Rezoning Transportation Analysis

Petition Number: 2025-128

General Location Identifier: 14117110, 14117112

Date	Description
12-22-25	First Review (CM)
1-22-26	Second Review (CM)
2-19-26	Third Review (CM)
3-23-26	Fourth Review (CM)
4-29-26	Fifth Review (CM)

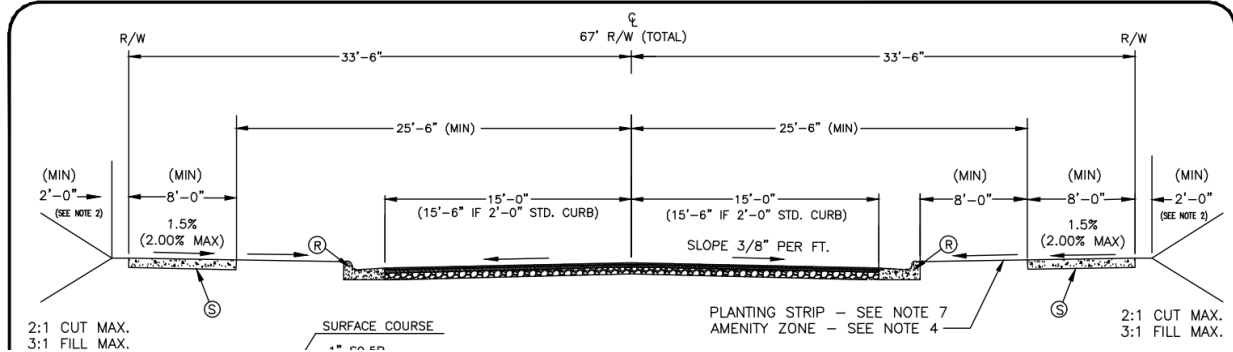
a. ~~Shopton Road:~~ Location of future curb and gutter is to be located 27' from centerline.

~~2+ Avenue, Buffered/Separated Bike Lanes~~

~~Label and dimension the curb and gutter from the centerline for each road on the site plan.~~

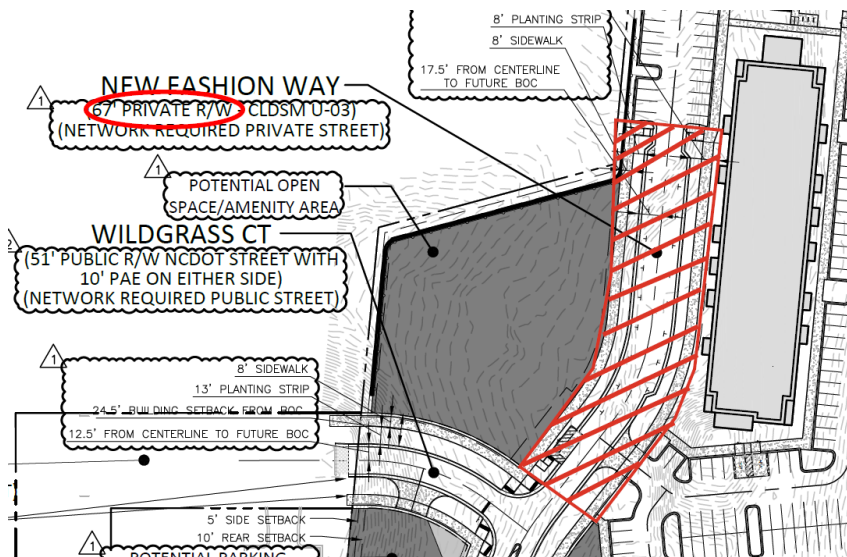
13. ~~Outstanding Issue From 12-22-25:~~ Revise site plan and conditional note(s) to construct 8-foot planting strips and 8-foot sidewalks on Shopton Road and internal public streets. The site plan shall label and dimension both items from the back of curb and gutter or edge of pavement. Add conditional note The entire facility must be outside of the right of way and within a public access easement. Add conditional note committing to construction and maintenance of the 8-foot sidewalks on Shopton Road and internal public streets.

~~Clarifying Comment 01-22-26:~~ This project is located within the Extraterritorial Jurisdiction (ETJ) and thus the Right-of-way line should be dedicated to the front face of sidewalk with a public access easement (PAE) dedicated over the sidewalk for all public roadways. Revise site plan and conditional notes to adjust the Right-of-way dimensions.

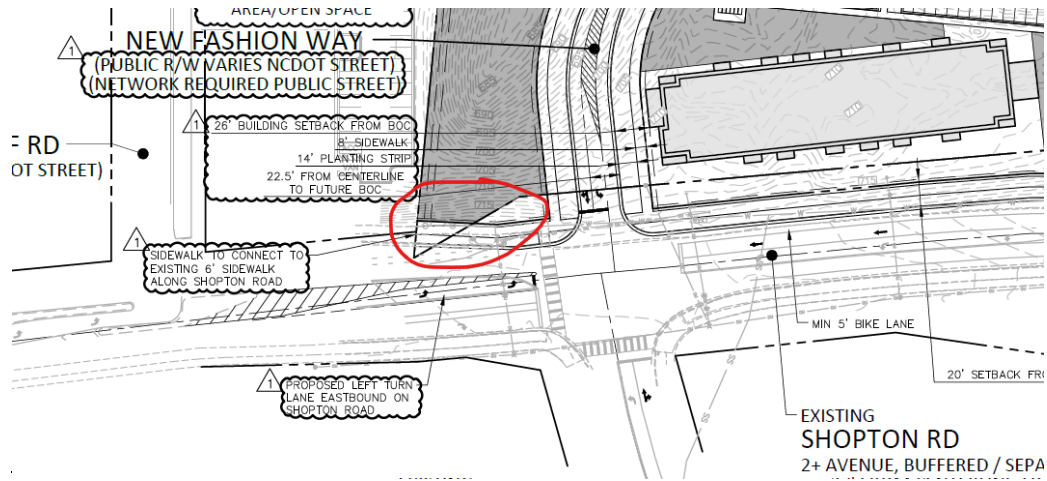
16. ~~New Comment 01-22-26:~~ Revise site plan and conditional notes to show New Fashion Way will have public access easement (PAE) in place of private Right of way. Identify northern limits of PAE along New Fashion Way.

~~Clarifying Comment 02-19-26:~~ Show the limits of the Public Access Easement on the plan and label as Public Access Easement (PAE) instead of private right of way.

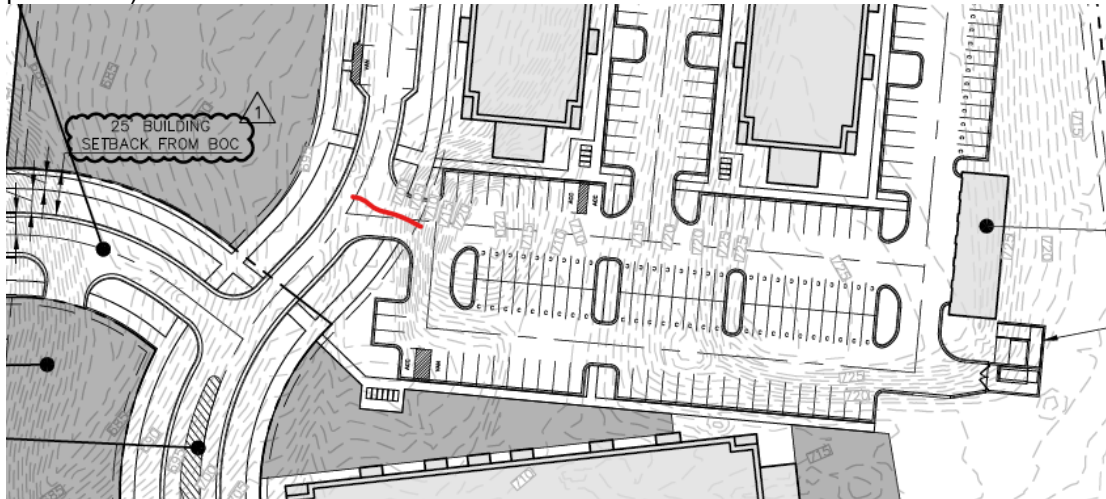
17. ~~New Comment 01-22-26:~~ Revise site plan to clean up ROW along Shopton Road to show appropriate ROW along entire frontage.

Clarifying Comment 02-19-26: Add dimension of ROW to the west of New Fashion Way to show that ROW meets minimum requirements along Shopton Road, and it will also show that the new and existing sidewalk are located within right of way for the entire frontage. Existing sidewalk along property frontage must be within Right of way or sidewalk utility easement (SUE).

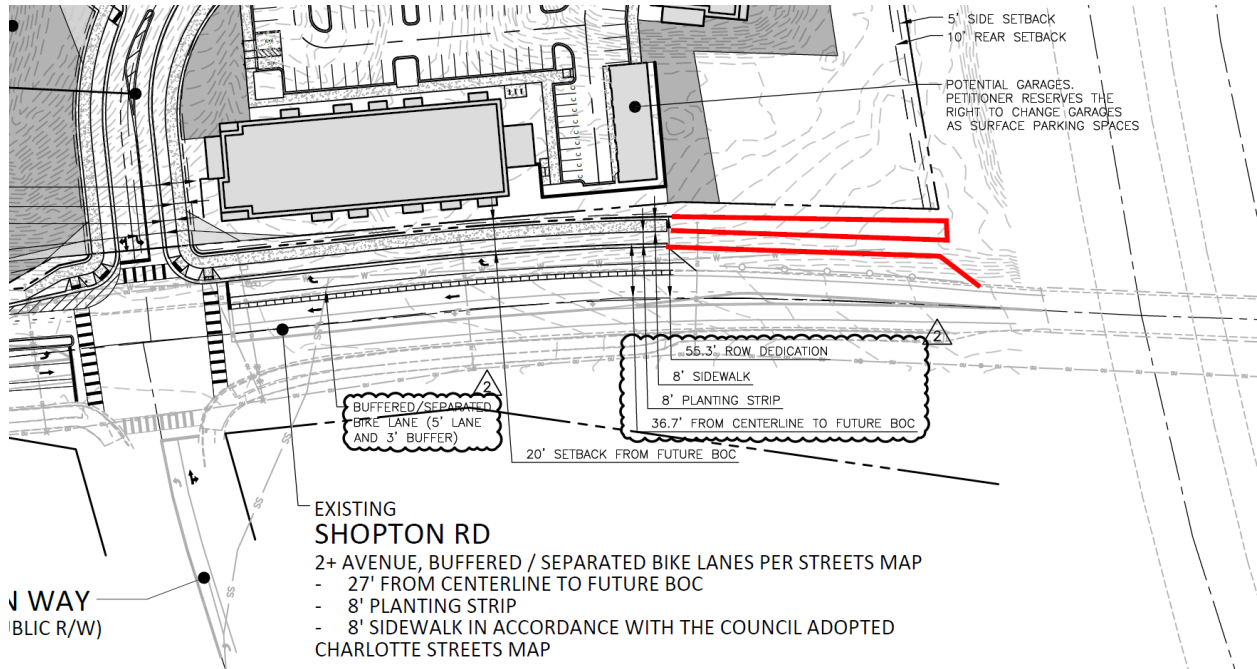
18. ~~New Comment 01-22-26:~~ Revise site plan to align driveway intersection at 90-degree angle (perpendicular).

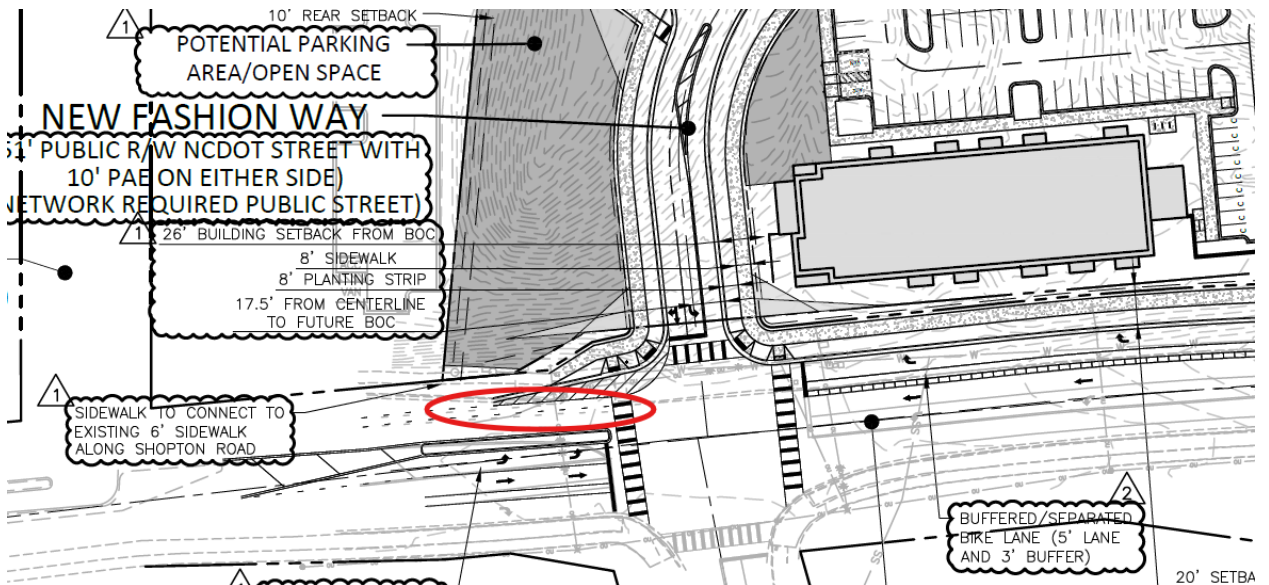
19. ~~New Comment 02-19-26:~~ Revise site plan to install roadway, bike lanes, and streetscape improvements along entire project frontage. You can add a note stating that limits of improvements will be coordinated with NCDOT/CDOT during permitting due to existing bridge and/or site conditions.

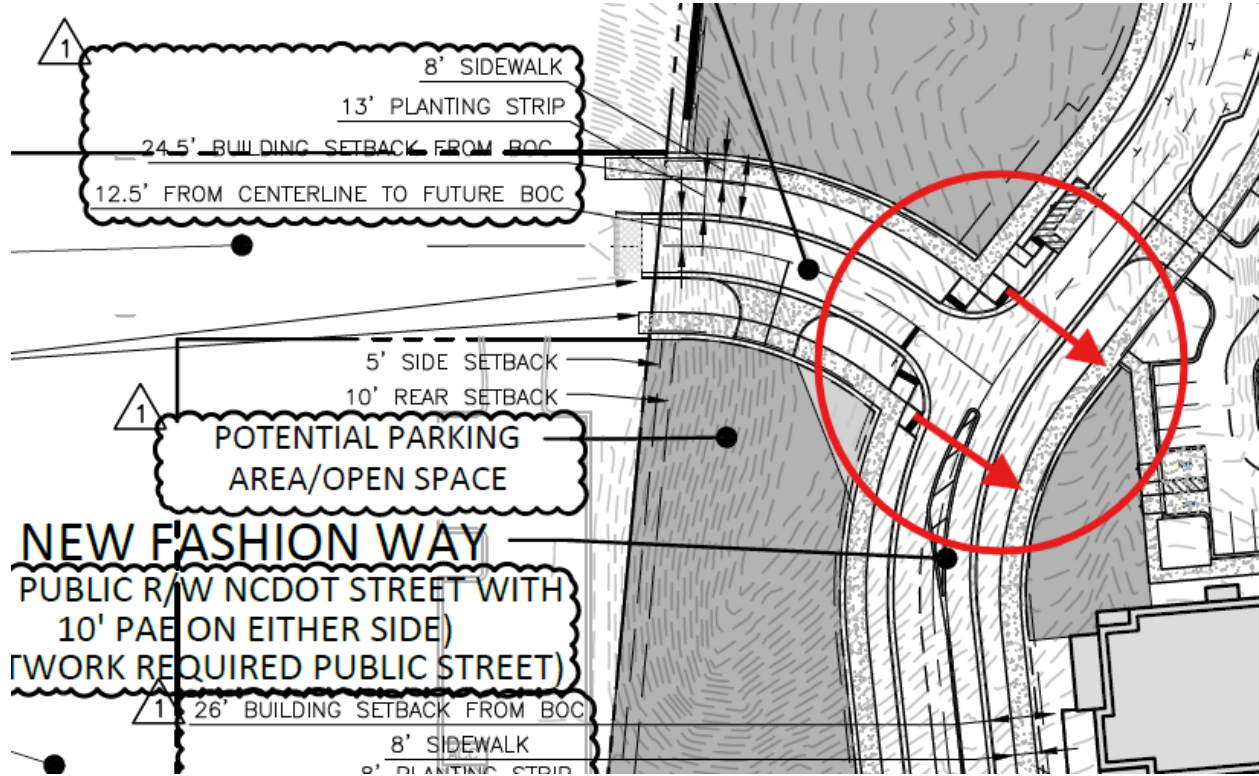
20. ~~New Comment 02-19-26:~~ Revise site plan to install buffered bike lane along entire frontage. Show buffered bike lane west of driveway along project frontage. Can add a note to coordinate with CDOT/NCDOT during permitting on bike lane transition.

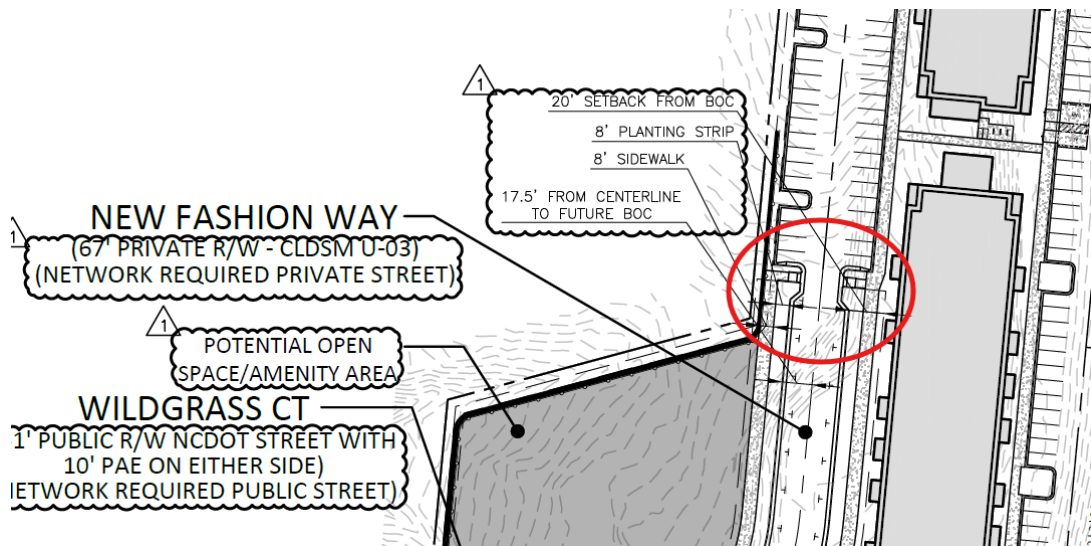
21. ~~New Comment 02-19-26:~~ Revise site plan to show receiving ramps across New Fashion Way.
